TECHNICAL BULLETIN

REWORK OF STATIC PRESSURE TUBE INSTALLATION TO MINIMIZE ALTIMETER NEEDLE OSCILLATION

500D Model 369D Helicopter Serial No. 0003D thru 0731D

Figure 1. Rework of Static Pressure Tube Installation

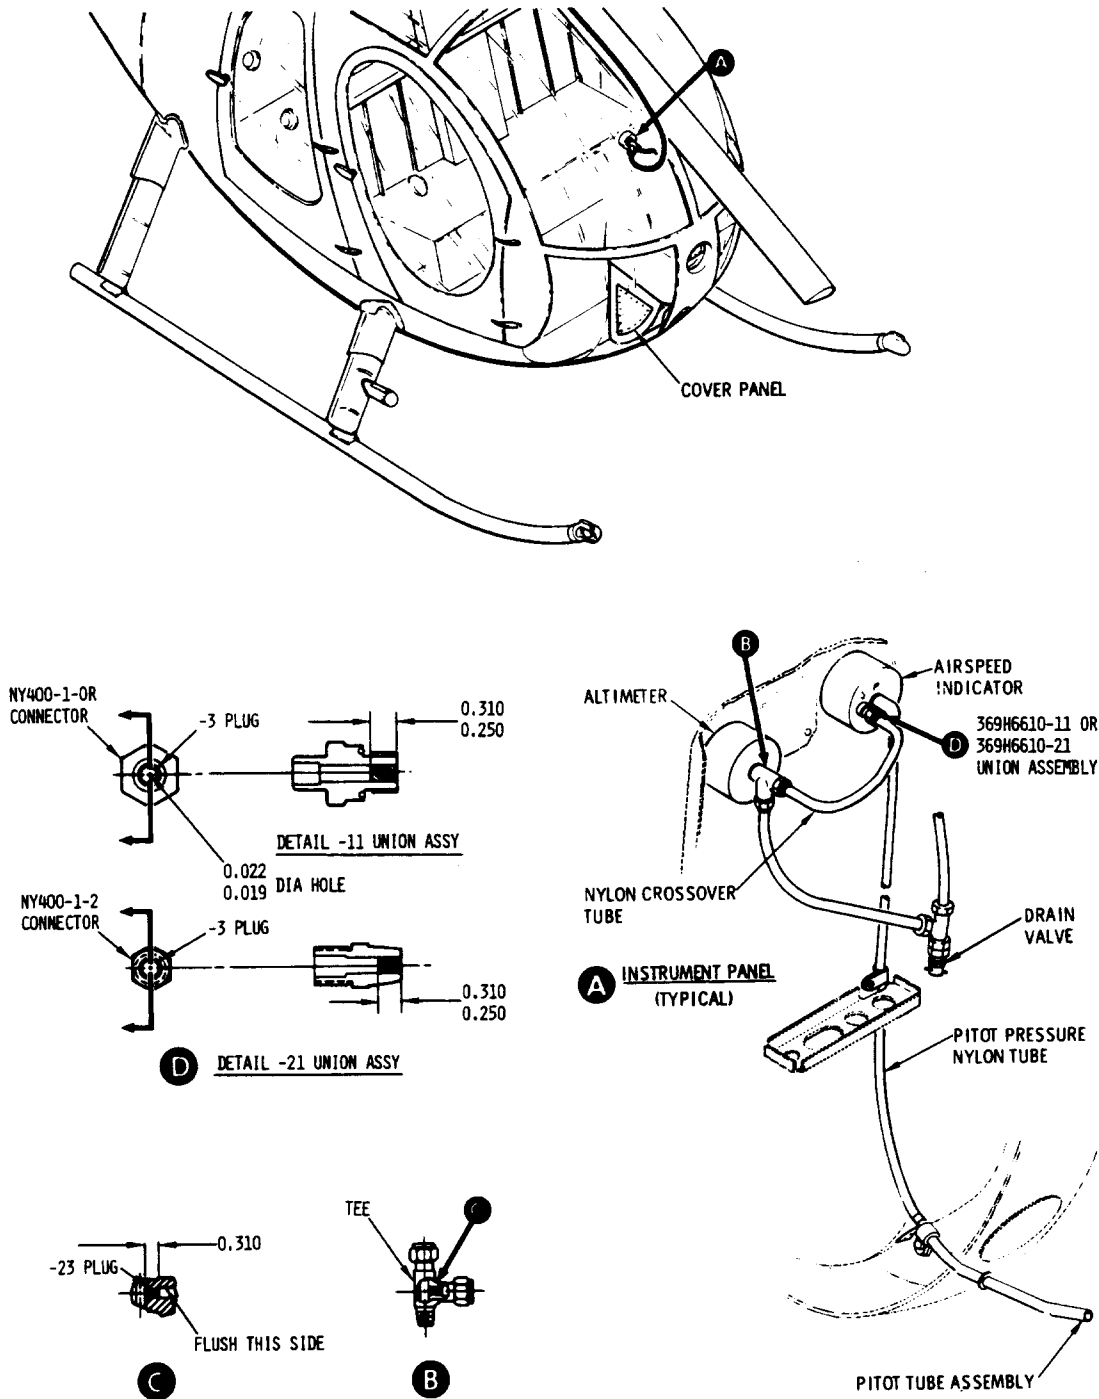
The information given in this Service Information Notice lists a procedure for rework of the hardware connecting the crossover tube between the altimeter and airspeed indicators on the instrument panel to reduce needle bounce. The rework consists primarily of removing the existing 369H6610-3 plug from the connector at the airspeed indicator and installing a new 369H6610-23 plug in the existing tee at the altimeter indicator.

- (1). Check that all electrical power is OFF.
- (2). Remove instrument panel fairing and hood, per HMI-Vol I.
- (3). Disconnect drain tube from 369H6628 tee at altimeter indicator. (See Figure 1.)
- (4). Press fit new 369H6610-23 plug into tee as show, reconnect drain tube to tee. (See View B.)
- (5). Disconnect crossover tube from connector at airspeed indicator.
- (6). Remove existing -3 plug from 369H6610-11 or -21 union assembly,
- (7). Reconnect crossover tube to connector at airspeed indicator.
- (8). Reinstall instrument panel fairing and hood.
- (9). Perform flight test to check instrument operation.
